Waterloo Estate (South) Planning Proposal – Submission

In February 2020 the Council and the Central Sydney Planning Committee (CSPS) approved a planning proposal and draft design guide for the Waterloo Estate (South). The proposal was informed by the City's Alternative Approach to Waterloo, that was in turn reviewed and guided by an Expert Advisory Panel that included:

The City makes the following recommendations for change to the planning proposal and the draft design guide prior to making the new planning controls for Waterloo Estate (South).

Figure 2: City's proposed height in metres map (LEP)

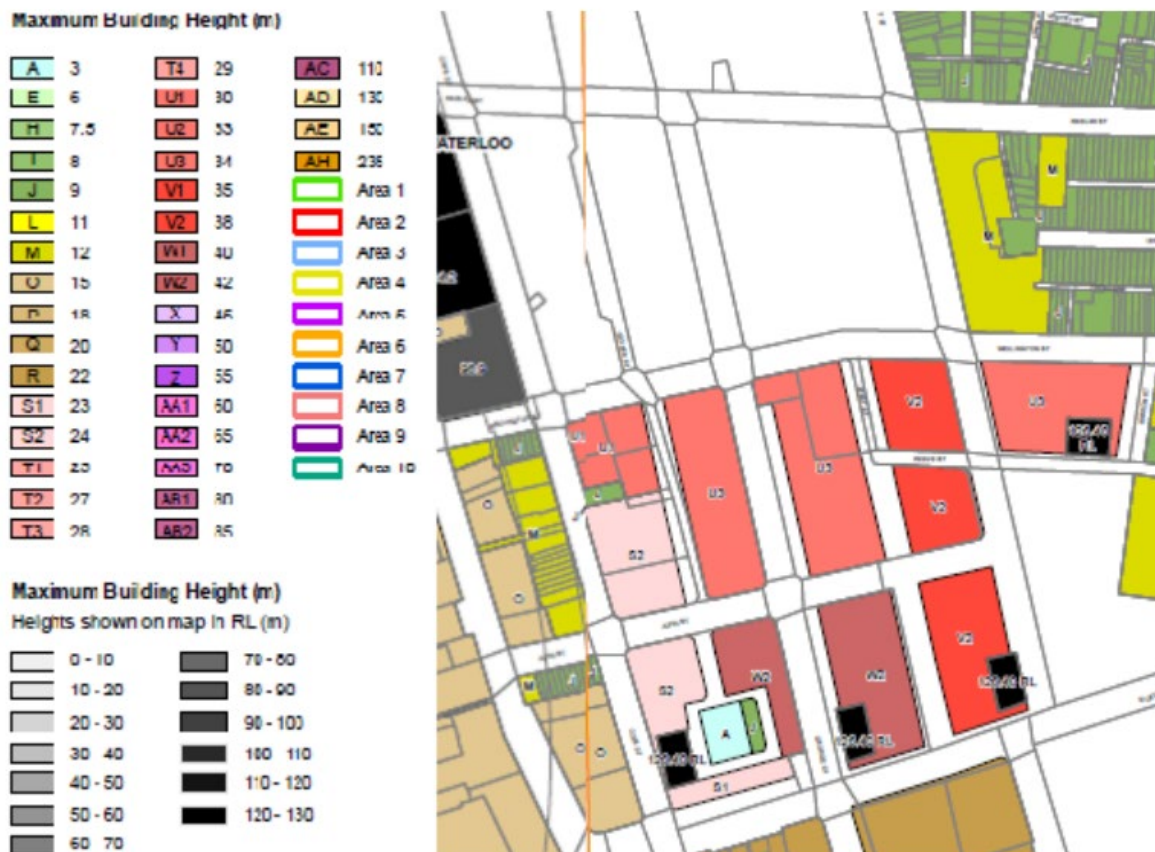
The maximum building heights in the planning proposal (LEP maps) (Figure 2) have significantly changed from what was proposed by the City (Figure 3). The change is prompted by the Gateway determination instruction to modify the height map to *"remove the 3m and/or 6m height control that depicts the location of private internal courtyards and apply the adjacent maximum heights"* and to *"set simplified maximum heights above ground on the Height of Building Map, including an allowance for roof top communal facilities and flood levels"*.

The simplification of the LEP maps allows for a significantly altered building envelope than that shown in the draft design guide and places several of the aims and principles of the planning proposal in jeopardy. Key risks include:

- placing heights on lots containing heritage items well beyond the existing height of the item;
- increased height immediately adjacent to heritage items;
- exposing narrower streets to heights that are in proportion to wider streets or park frontages on the opposite side of the blocks;
- loss of articulation of height in relation to street width and orientation, park frontage, [and](#) corner emphasis;
- substantial decreases of sun access to streets and parks;
- loss of relationship to areas subject to flooding; and
- loss of relationship to the topography.

- Reconsider and adopt where relevant the reduced building heights along streets shown in the preferred direction of the Addendum Urban Design Review.
- Rework the maximum building height map in the planning proposal to have height zones relating to street widths and park locations.
- Reconcile the height in storeys map in the draft design guide, with the maximum height of buildings map in the planning proposal to ensure they are consistent. This is to provide clarity for the community and future landowners and ensure certainty in the development application process.
